PLANNING, ZONING, & BUILDING DEPARTMENT
PZ&B Combination Staff Memorandum: Architectural Commission and Town Council

SUBJECT: ARC-23-032 (ZON-23-041) 176 SEMINOLE AVE (COMBO)

MEETING: JUNE 28, 2023 ARCOM
JULY 12, 2023 TC

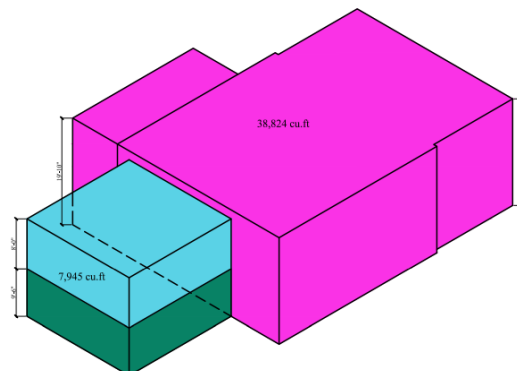
Variance #3 requests to exceed the maximum Cubic Content Ratio (CCR). The existing property maintains a non-conforming CCR of 4.05, in lieu of the 4.0 maximum allowed. The March ARCOM application sought to increase the CCR to 4.41. The June ARCOM submittal reduces the request to 4.39.

Designed in 2003, the residence features a one-story garage element on the southern portion of the site. One-story portions of residences can serve as transitional design elements to sensitively address massing concerns of abutting

properties; however, this garage portion abuts a discordant commercial zoning district (C-TS) to the south, which allows three stories in height under the Special Exception process.

From the east property line, the garage maintains a setback of roughly 28' from the neighboring residential lot, which recently received ARCOM approval for the construction of a new single-story single-family residence. The subject structure is currently over the allowable CCR (likely an oversight during permit review). In this instance, staff opines that the addition of the new second floor over the existing one-story portion would likely not overwhelm the overall massing of the property on site—as the primary massing element features prominent two-story form more proximate to Seminole Avenue and N County Road.
